Responses to CEC Workshop Requests: Nos. A1 through A32

Amended Application for Certification for HYDROGEN ENERGY CALIFORNIA (08-AFC-8A) Kern County, California

**RESPONSES TO WORKSHOP REQUESTS A1 THROUGH A32
FROM CALIFORNIA ENERGY COMMISSION (CEC)**

FIGURE A14-1

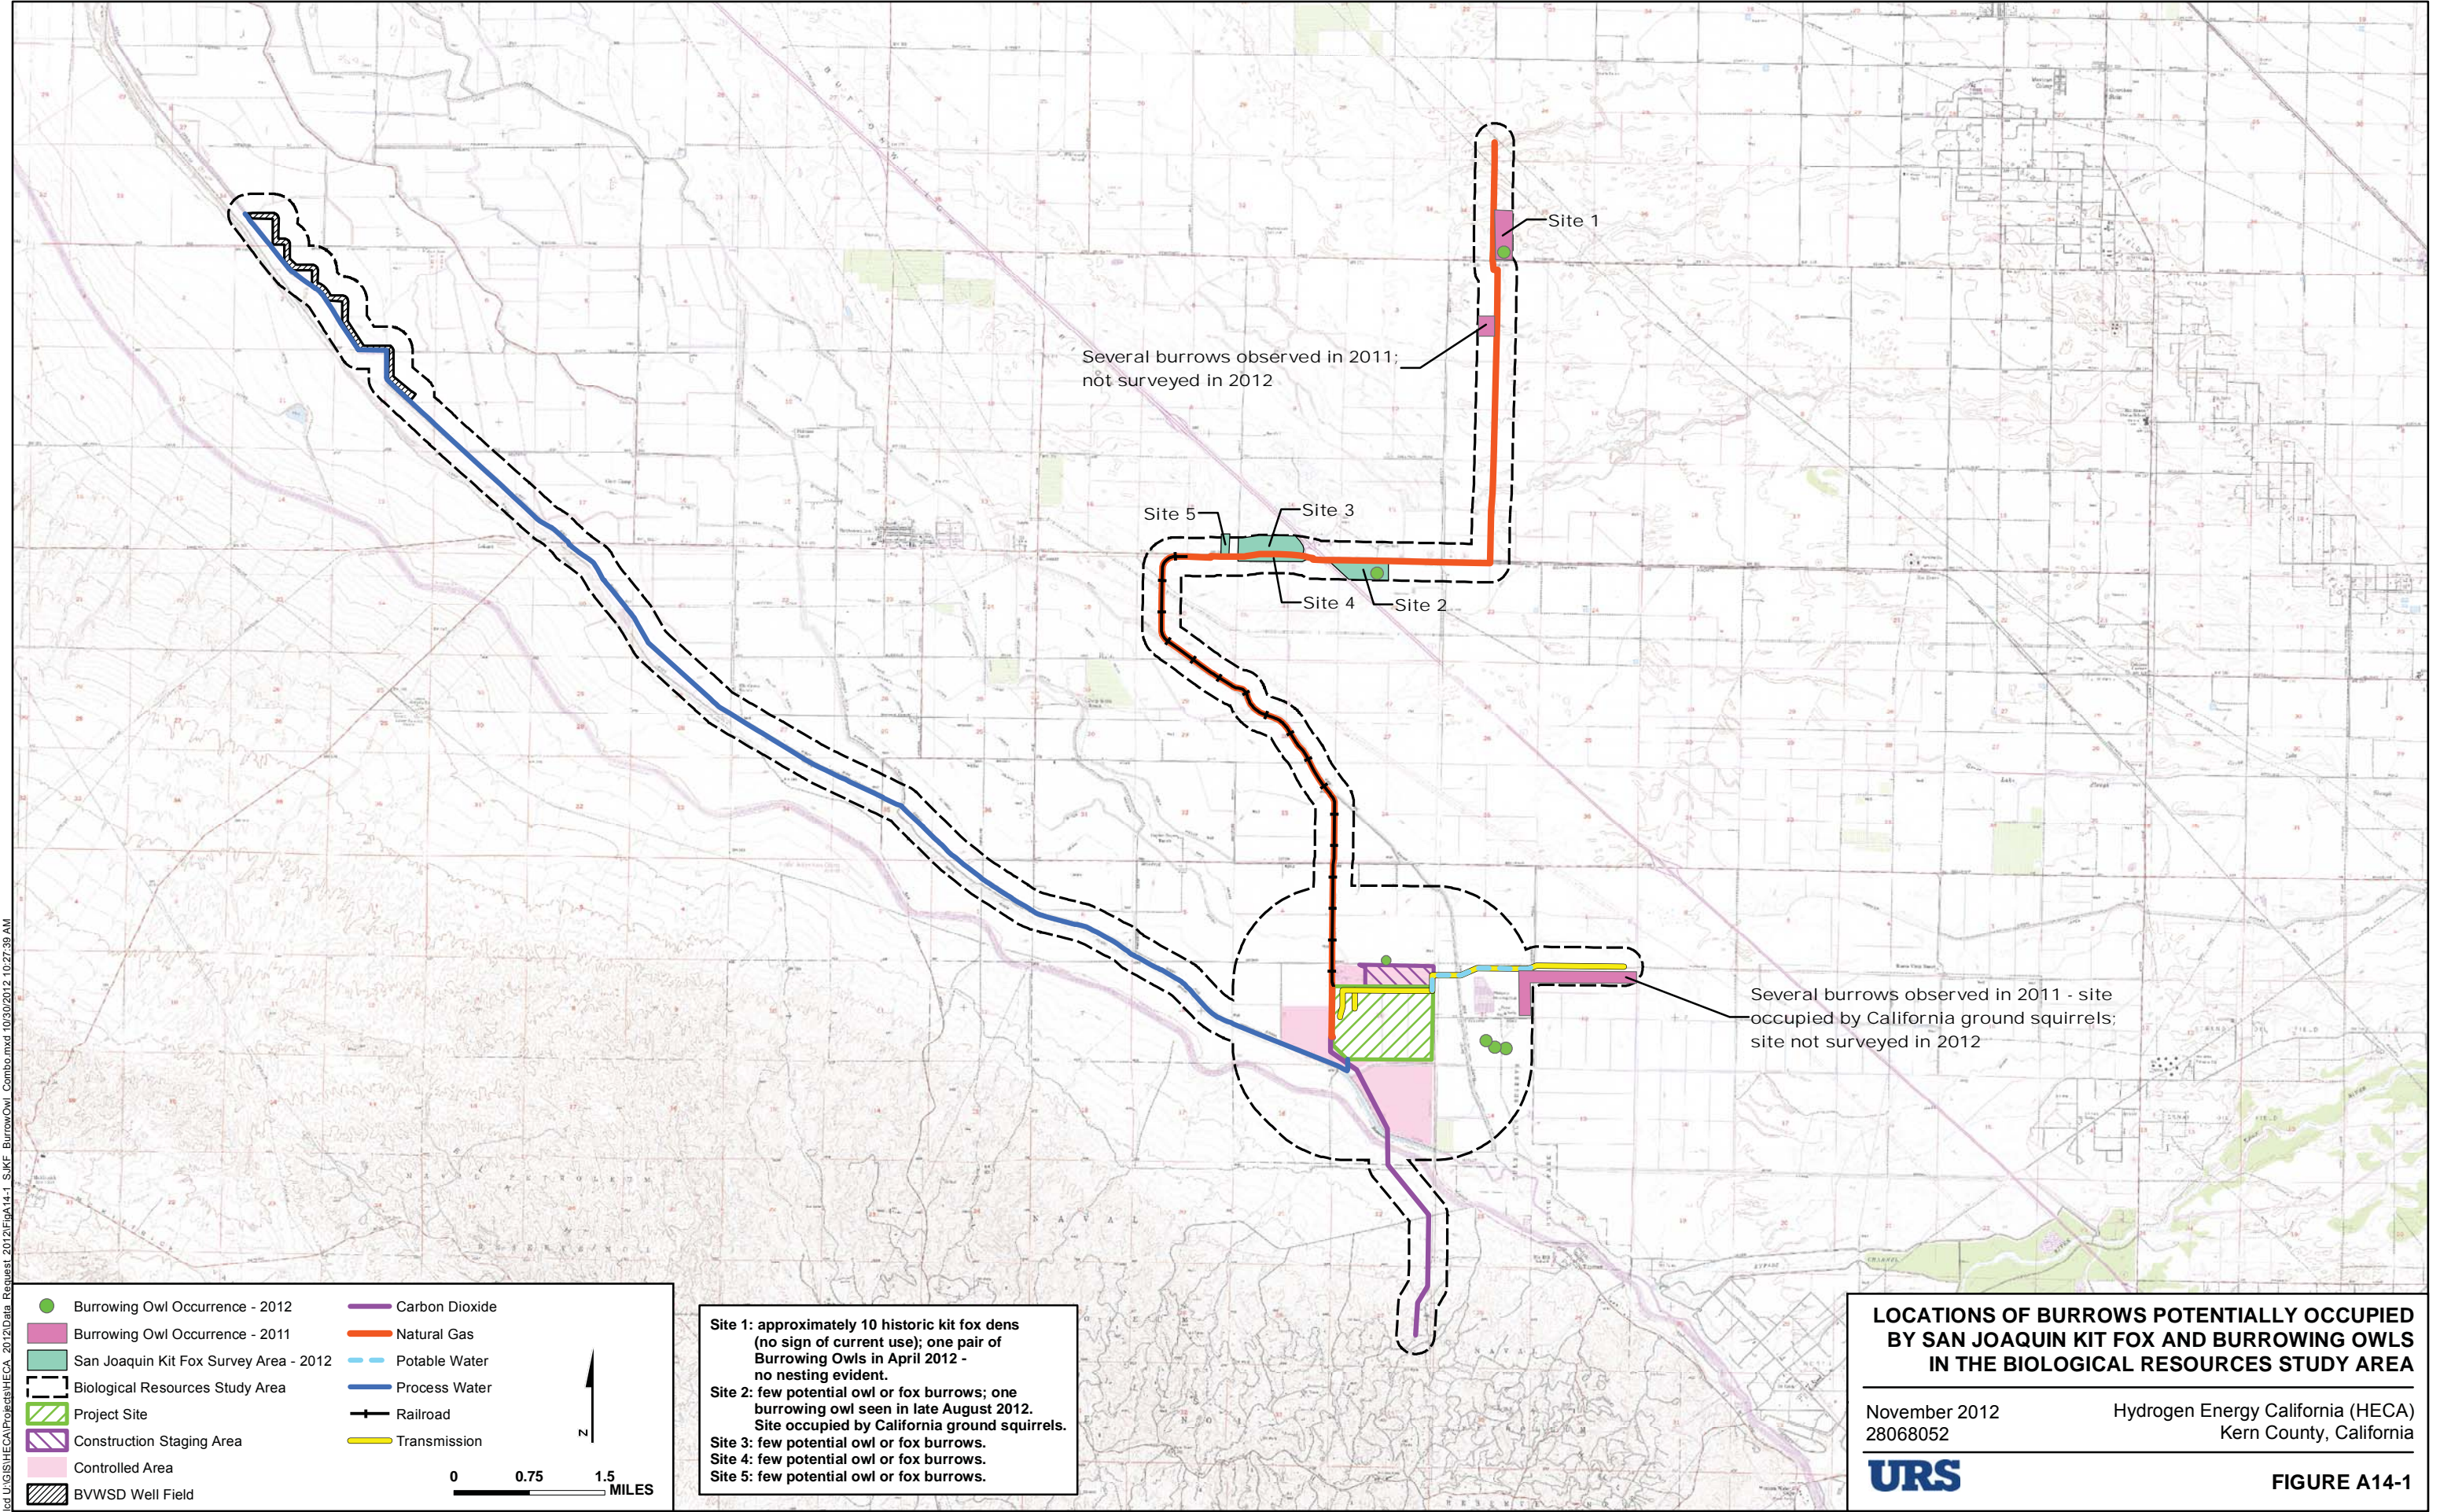
A14. Please provide a figure showing all collected kit fox sign GPS data, to date.

A15. Regarding data response A44, please provide more clarification on the “previously vacated dens observed along Site 1 near Magnolia Rd” following USFWS’s San Joaquin Kit Fox Survey Protocol for the Northern Range (FWS 1999). Classify the dens as known, potential, atypical, or natal/non-natal and describe the sign observed to determine den status.

Figure A14-1 illustrates the locations of burrows identified within the BRSA that could potentially be occupied by kit fox or burrowing owls. No kit fox signs (tracks, scat, prey remains) have been observed in the BRSA for the HECA Project.

The potential den observed at Site 1 near Magnolia Road (see Figure A14-1) had no kit fox sign, and did not appear to have been occupied within the past 5 years, based on the lack of disturbance and vegetation associated with the soil surrounding the potential den opening.

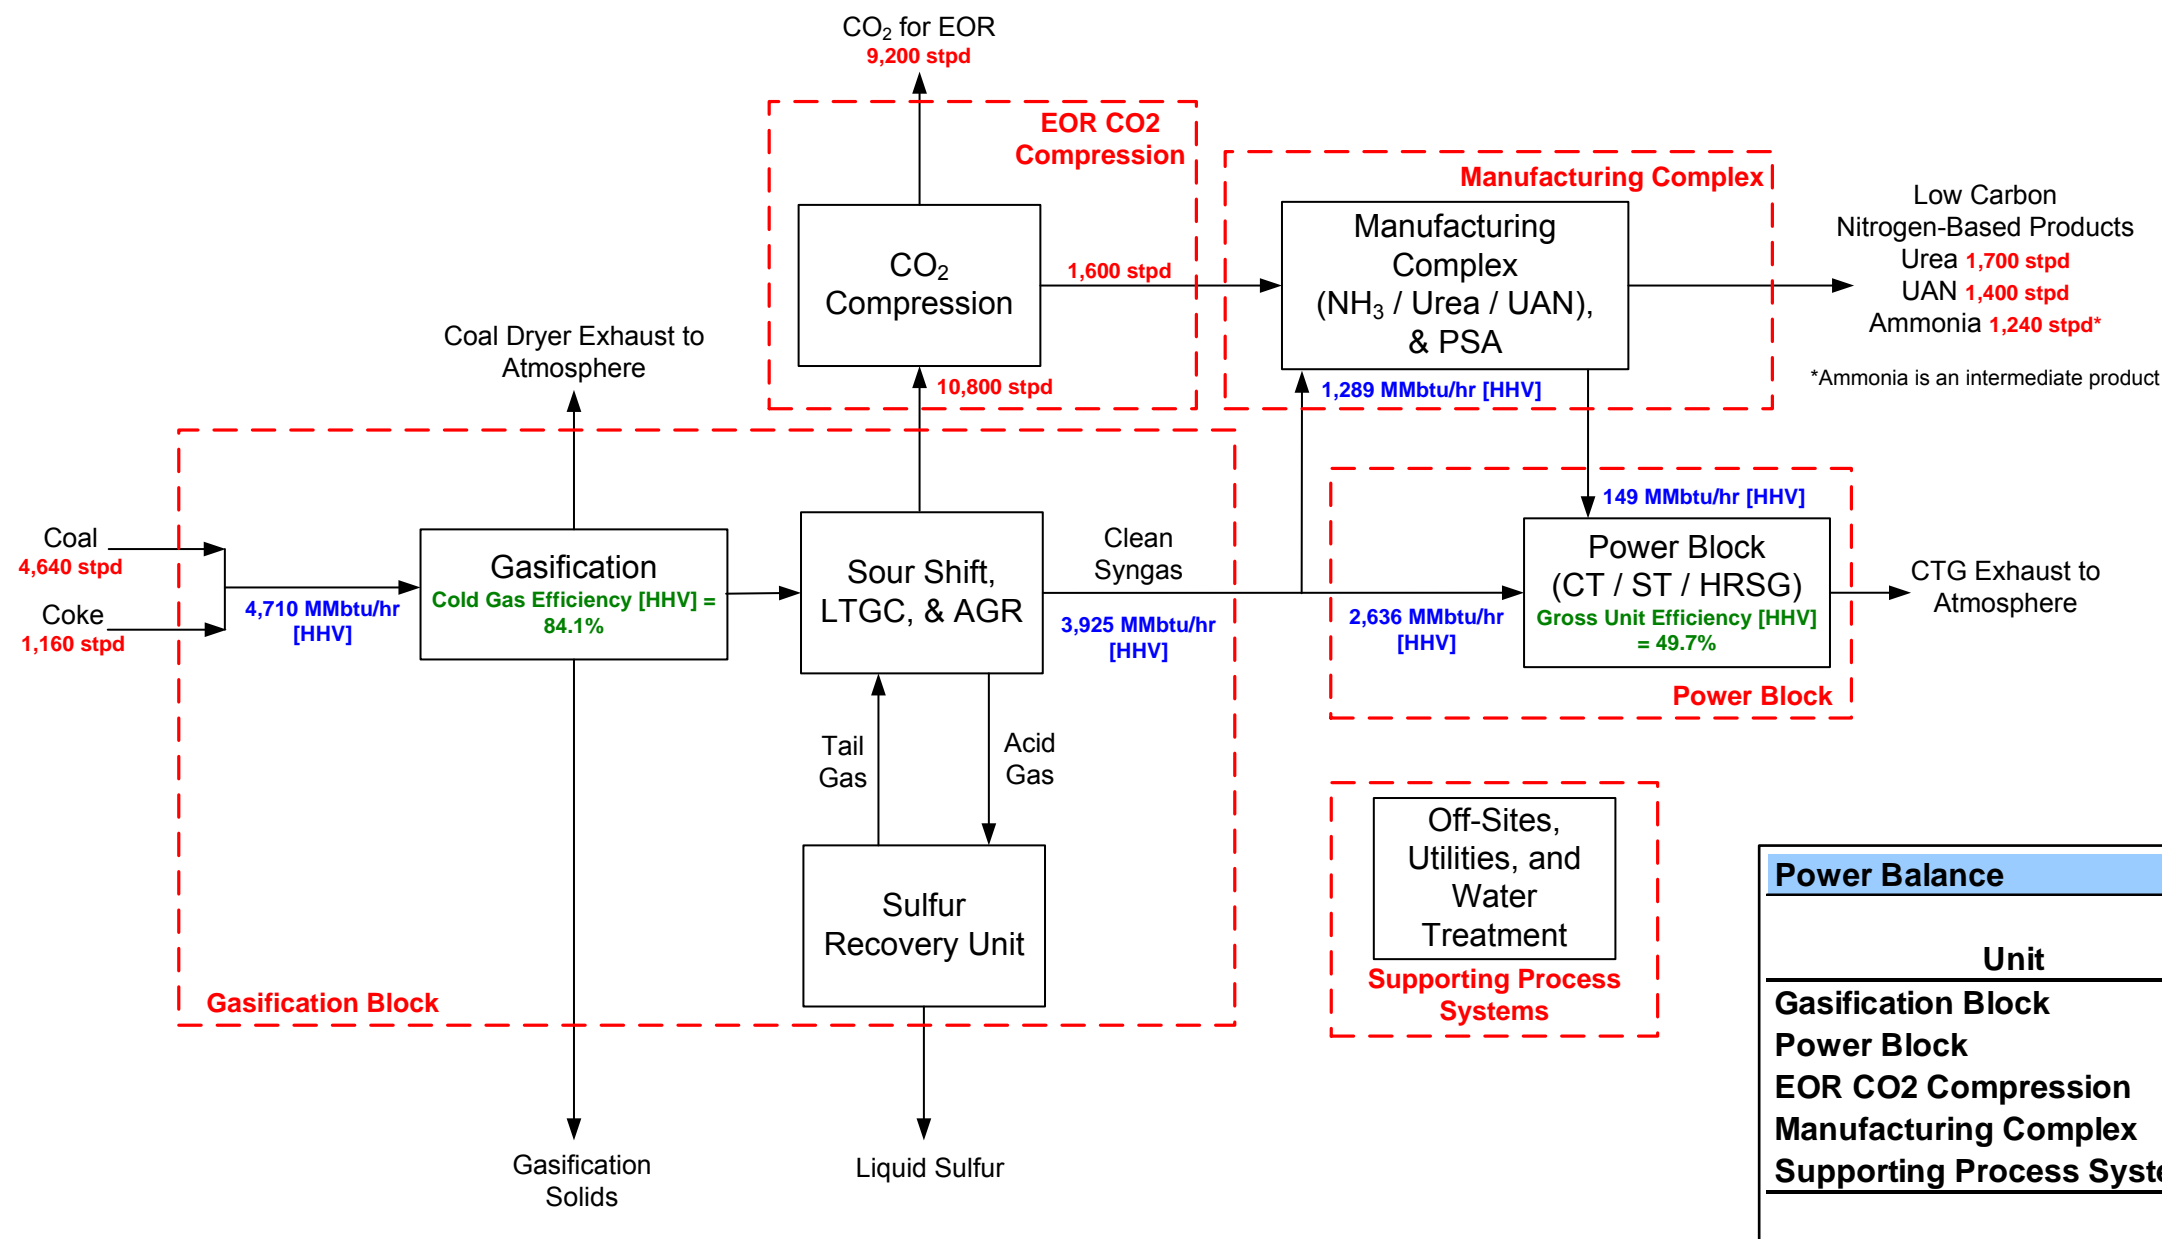
A27. *Regarding Data Requests A14-A16, A90: Provide additional detail on heat and energy balances. Provide balances for four categories to address efficiency and production in each category.*

The Applicant has prepared Figure A27-1 to provide additional detail on heat and energy balances for the four categories (i.e., Gasification Block, Power Block, Manufacturing Complex, and Enhanced Oil Recovery CO₂ Compression). This figure supplements the previous response provided to Data Request A14. The fuel energy content of the process streams flowing into and out of each block is shown. Also shown is the Gasification Block cold gas efficiency and the gross Power Block efficiency. Power generation and auxiliary load consumption are shown in the table included on Figure A27-1.
